PLANNING COMMISSION REPORT OCTOBER 13, 2026 AGENDA

Agenda Item:	Subject:	Submitted By:
Agenda Items 6D & 7D	Application for Preliminary Plat of Lots 1-4 and Outlots X-Z, Springfield Landing submitted by Springfield Landing, LLC, subdivider/owner, on property generally located at the northwest corner of S 6 th Street & Pflug Road	Kathleen Gottsch City Administrator

SYNOPSIS OF PROFESSIONAL STAFF COMMENTS FOR PLANNING COMMISSION & CITY COUNCIL

Lots 1-4 and Outlots X-Z, Springfield Landing Plat 1 Springfield Landing, LLC (Owner & Subdivider)/Snyder & Associates, Inc. (Agent) Preliminary Plat Application

FINAL PLAT

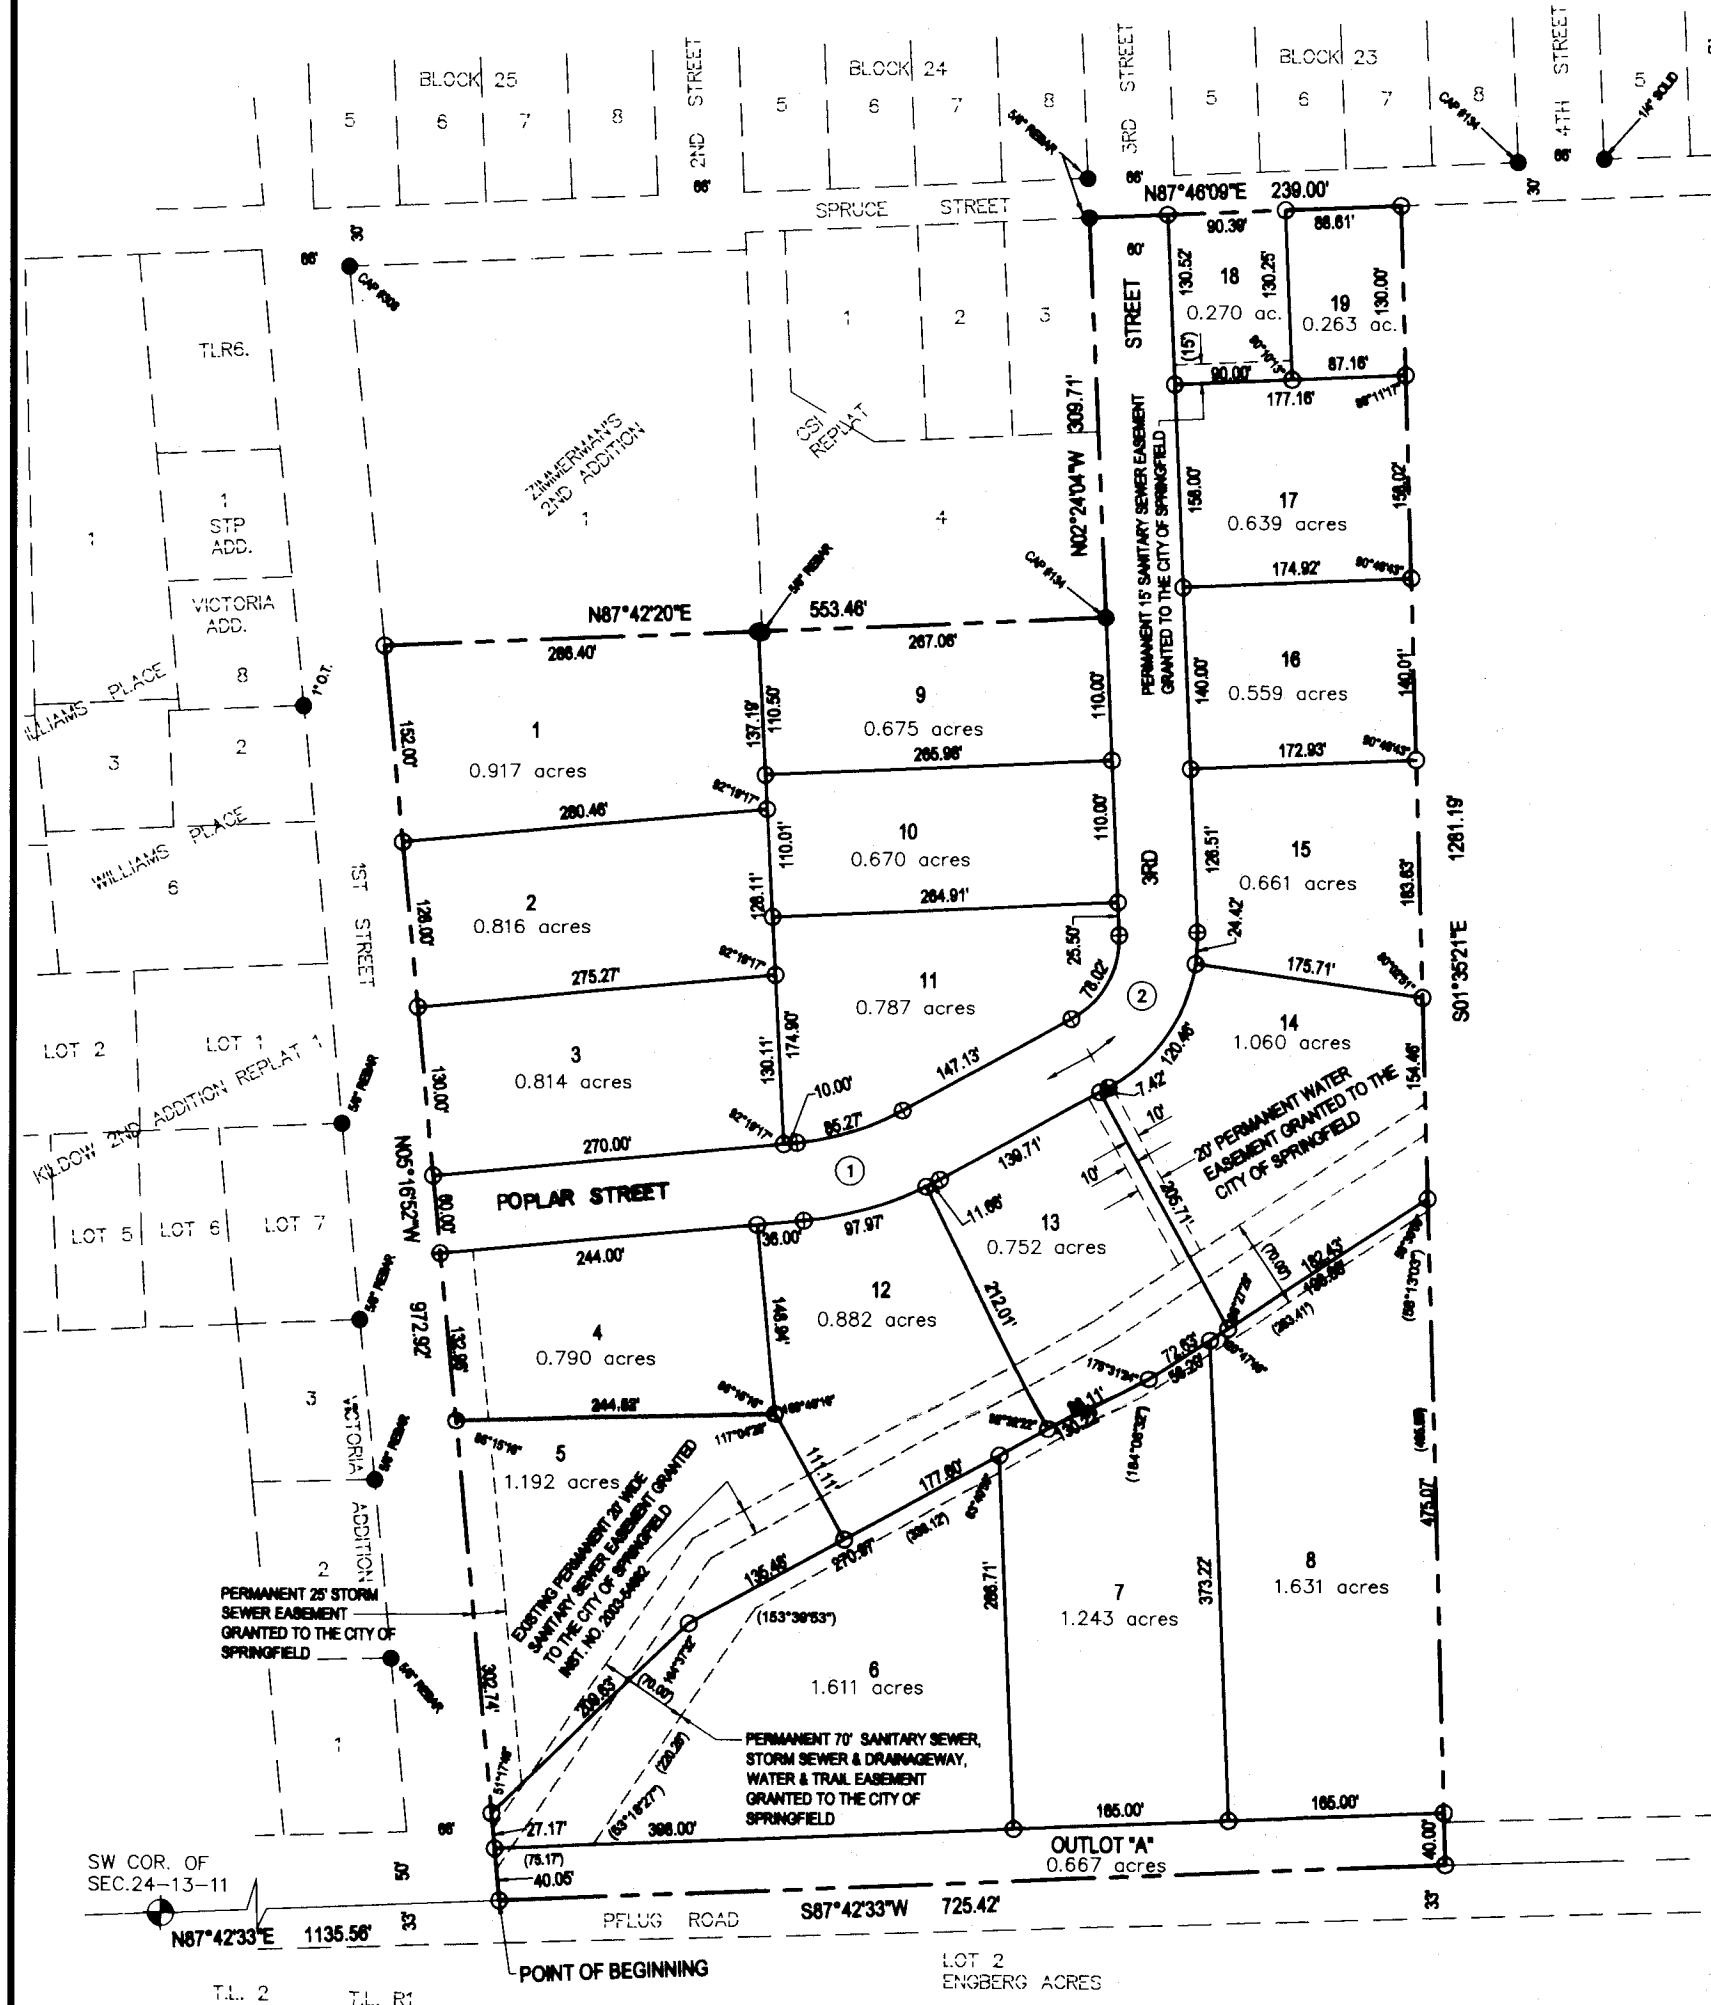
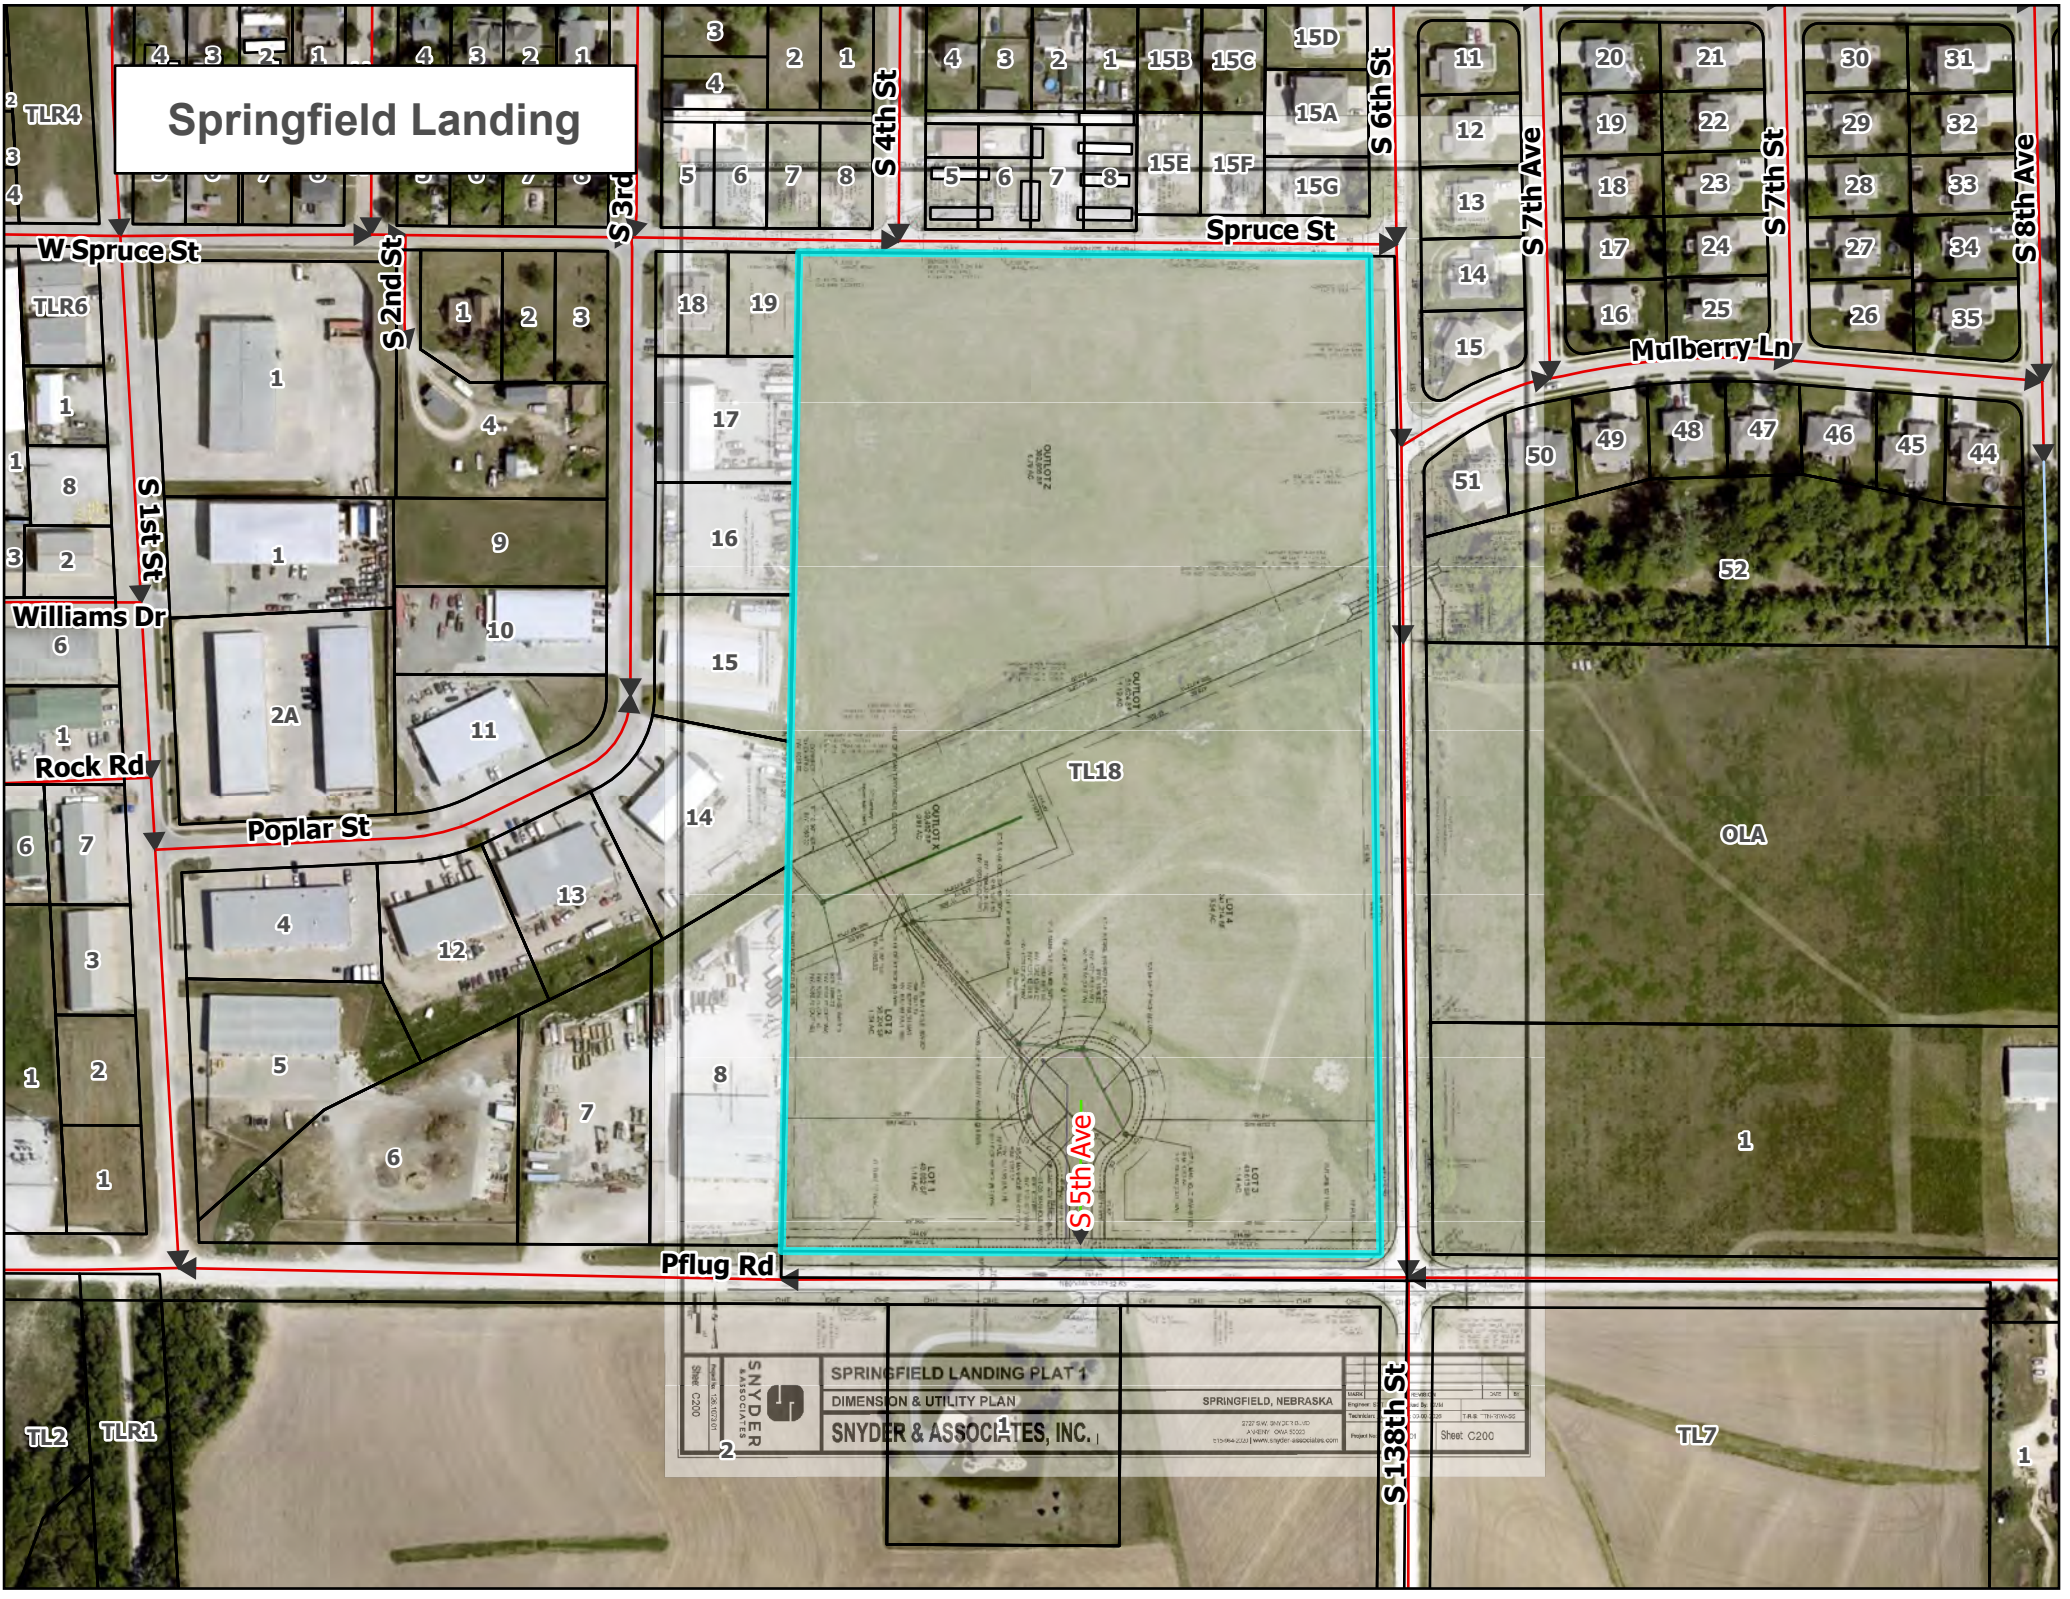
1. Add a Preliminary Plat sheet to the plan set, showing only the plat linework, without utilities, etc.
 - a. Adjust west end of Outlot Y to align with 70' easement shown on Industrial Park plat (**see attached Final Plat for Springfield Industrial Park.pdf**).
 - b. Adjust remainder of Outlot Y to align with north side of existing sanitary sewer easement and offset 70' south.
 - c. Rename Outlots X, Y, Z to Outlots A, B, C.
2. Add a Paving Plan sheet to the plan set, showing only the proposed streets, sidewalks, and trails.
 - a. Subdivider to install an 8' wide trail along the north side of Pflug Road and the west side of 6th Street upon completion of county road project.
 - b. The county project will grade out the full ROW section for the trail to be constructed by the developer.

GRADING PLAN

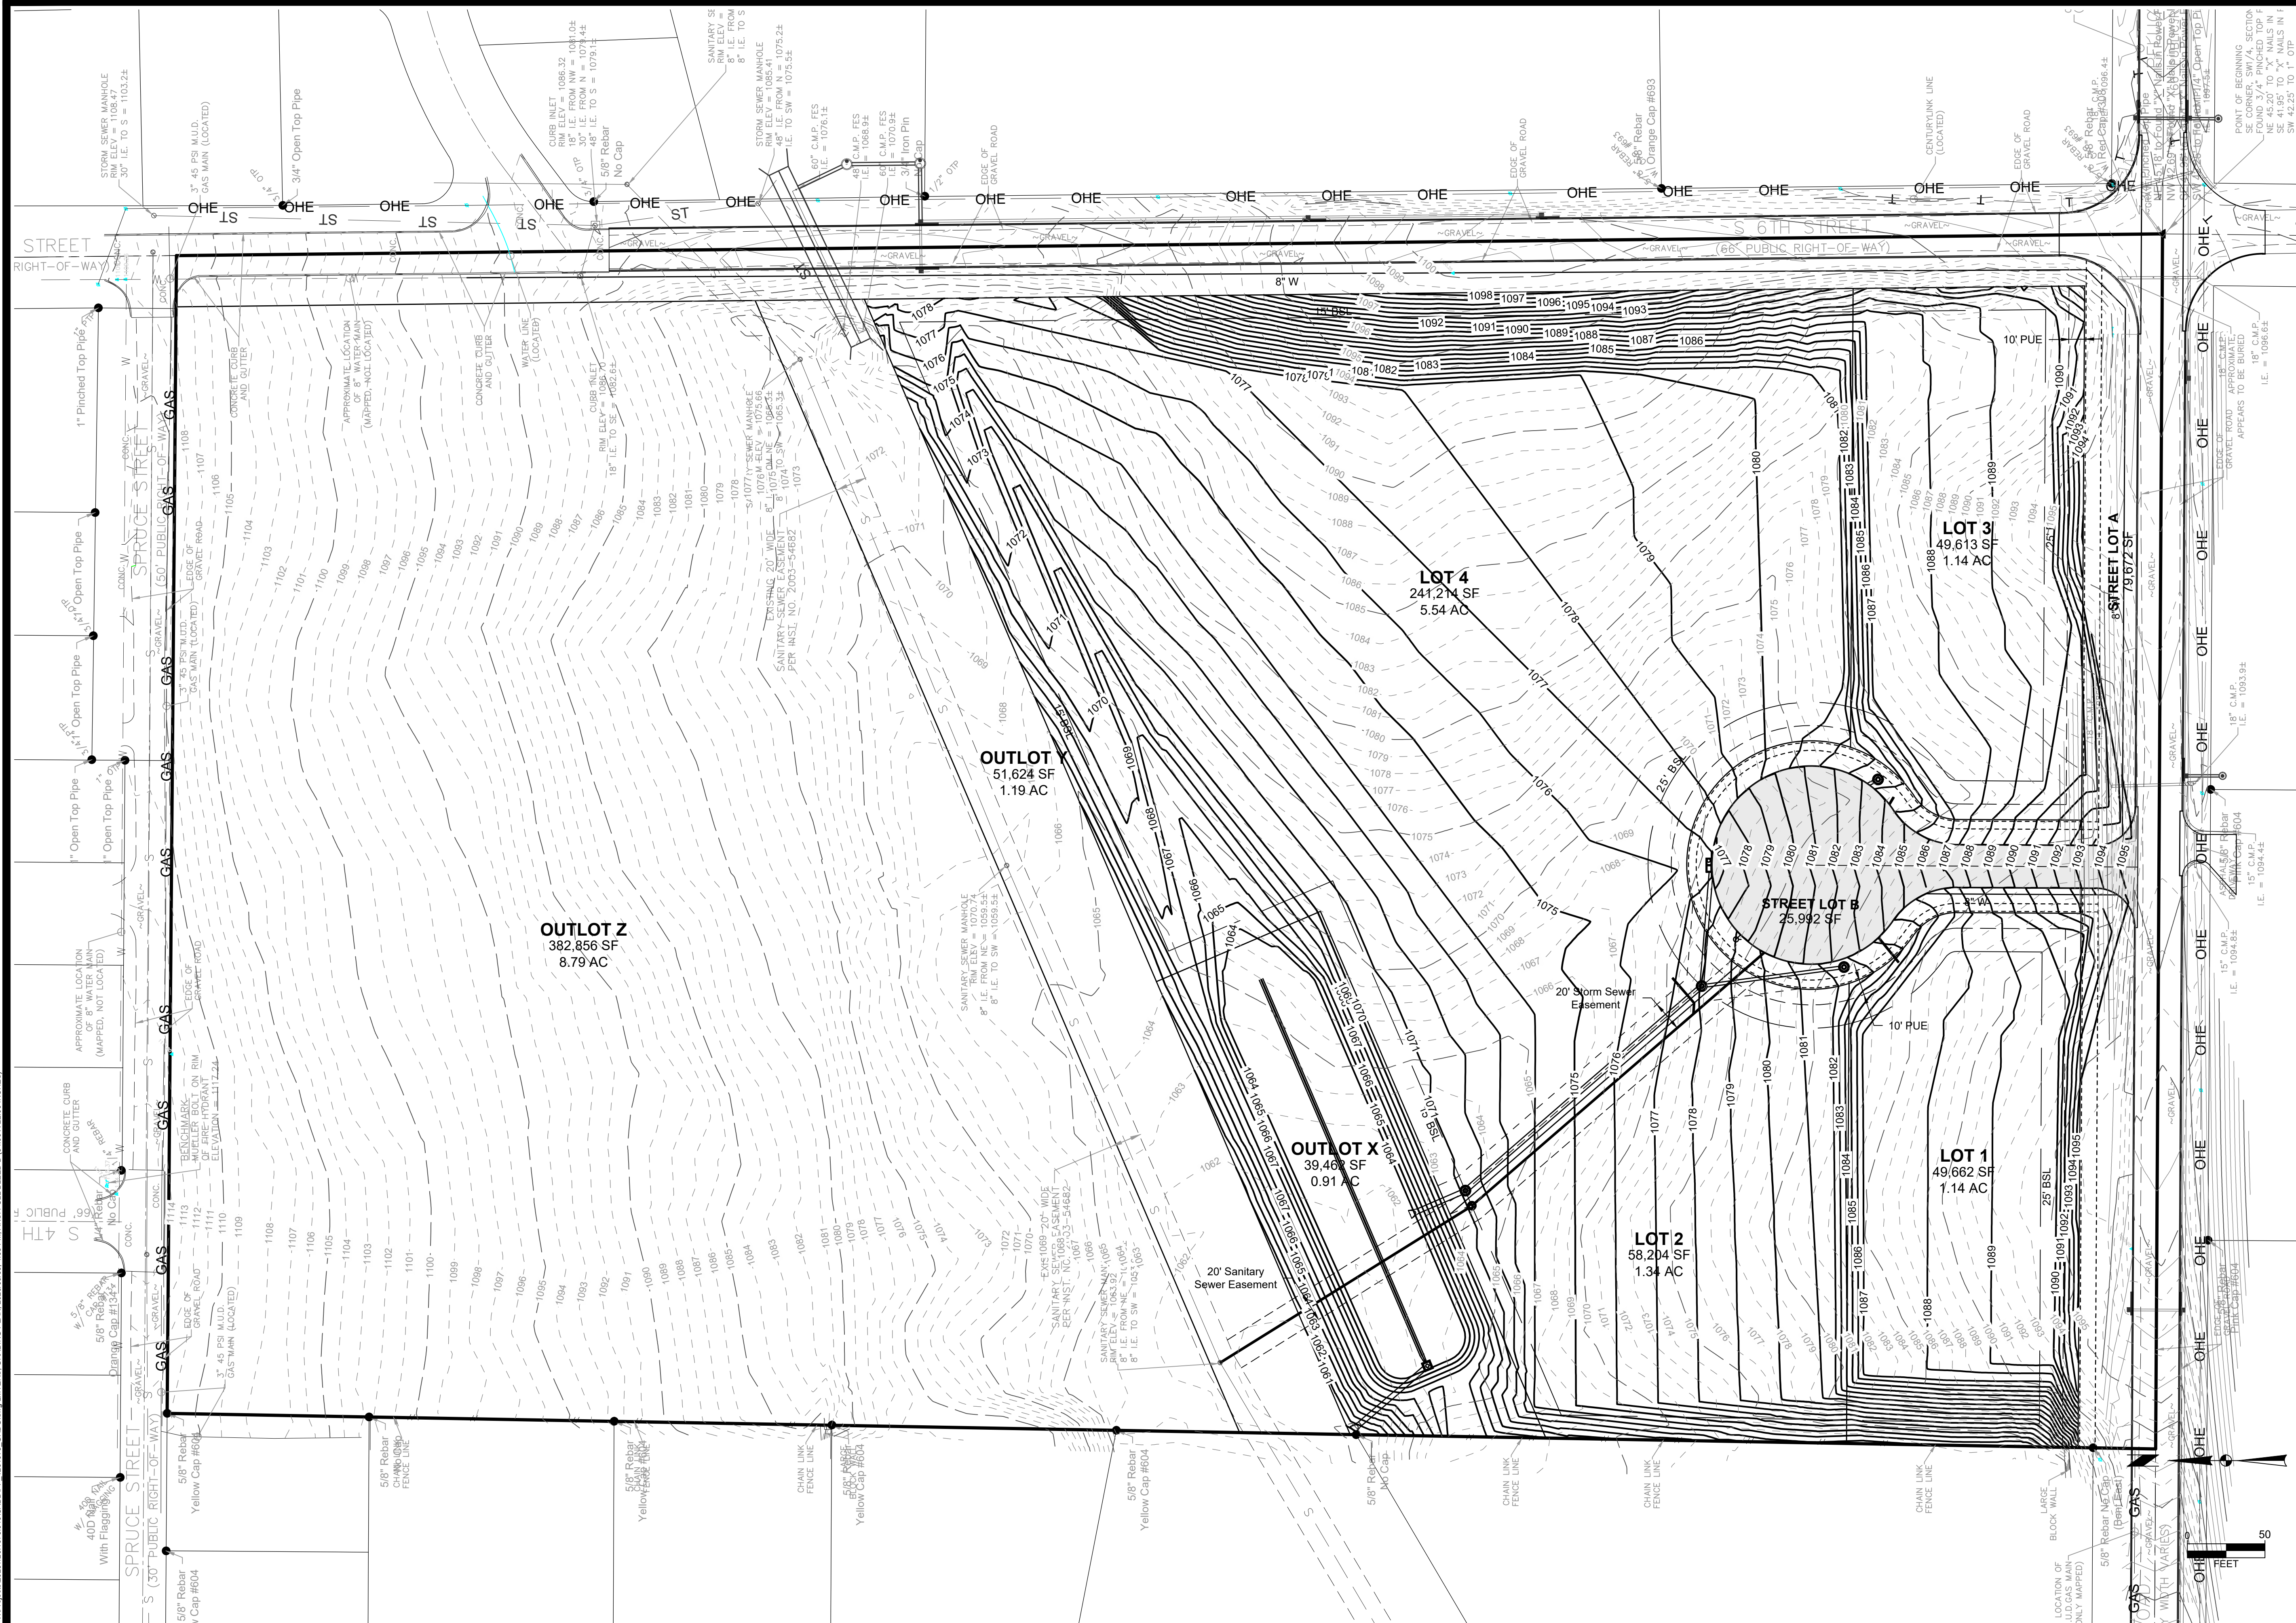
4. The plat does not propose to dedicate any area to public right-of-way or improvements. The Grading and Utility plan depicts a Street Lot B and a Street Lot A. "Street Lot" is not defined in the Springfield Subdivision Regulations or the Springfield Zoning Code.

5. I take the depiction of Street Lot A and Street Lot B on the Grading Plan as a private Street.
6. Under Springfield Subdivision Regulation 4.14, new private streets may be created as part of a Planned Development District. Private streets are also discussed in section 6.01 of the Subdivision Regulations.

7. The grading plan depicts Street Lot A adjacent to Pflug Road. The impact of that design and the possibility of any future assessment for improvements of Pflug Road should be considered.
